DCE MEMORANDUM NO. 19-08
(FHWA Approved: 7/16/08)

SUBJECT: CHANGES TO INDEX 11200, 11300 AND 11860

This memo is issued to allow the contractor to use the recent changes to Index 11200 and 11860 of the Design Standards. Please refer to the attached Design Standards.

2008 Interim Design Standard
MULTI-COLUMN GROUND SIGN

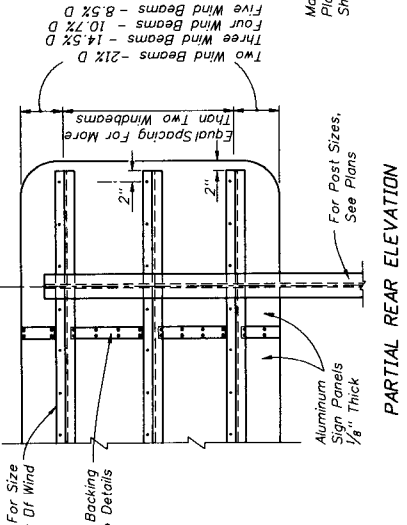
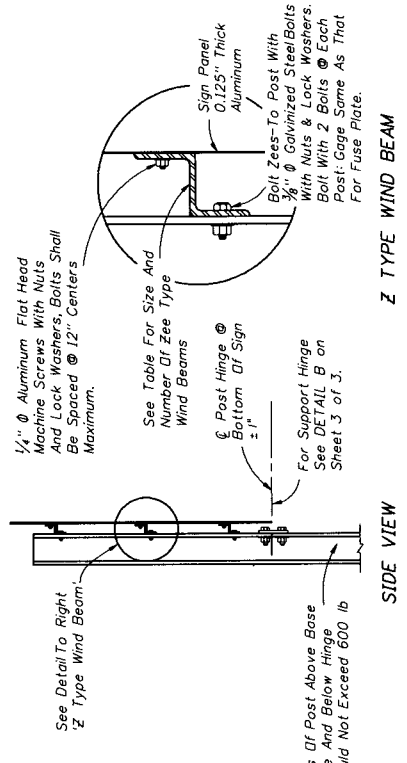
- Index 11200, Sheet 1 or 3, was modified to allow a horizontal panel splice at an interior Z bar support if the sign panel is deeper than **10 feet**, (instead of 12 feet).

Note: If the sign panels are deeper than 10', horizontal panel splices are allowed as long as the Z support strip drawings shall be followed. Minimum panel section width = 2'-6".

OVERHEAD SIGN STRUCTURES

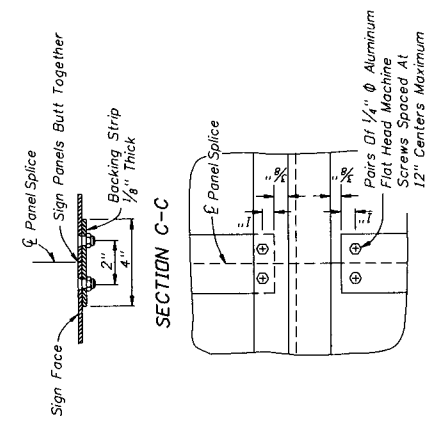
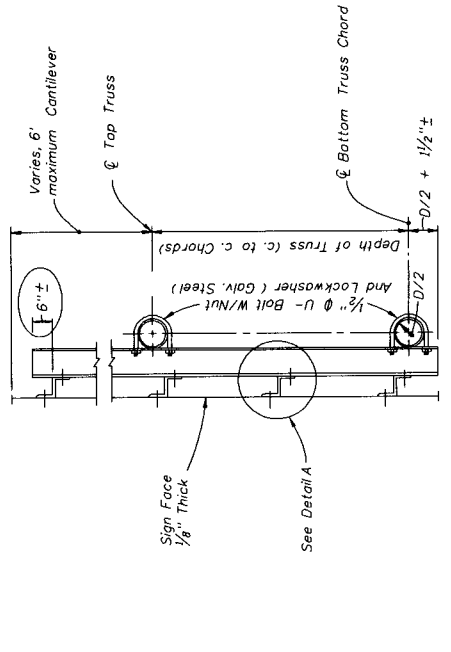
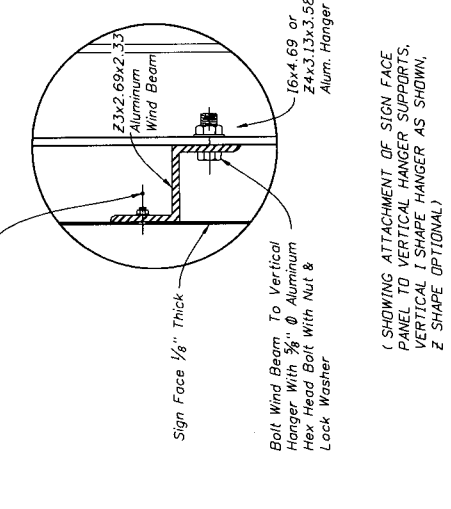
- Index 11200, Sheet 3 of 3, was modified to allow **Class I (Special) Concrete** in the foundation (instead of Class II Concrete).
- Index 11300, Sheet 1 of 1, was modified to allow a horizontal panel splice at an interior Z bar support if the sign panel is deeper than **10 feet**, (instead of 12 feet).
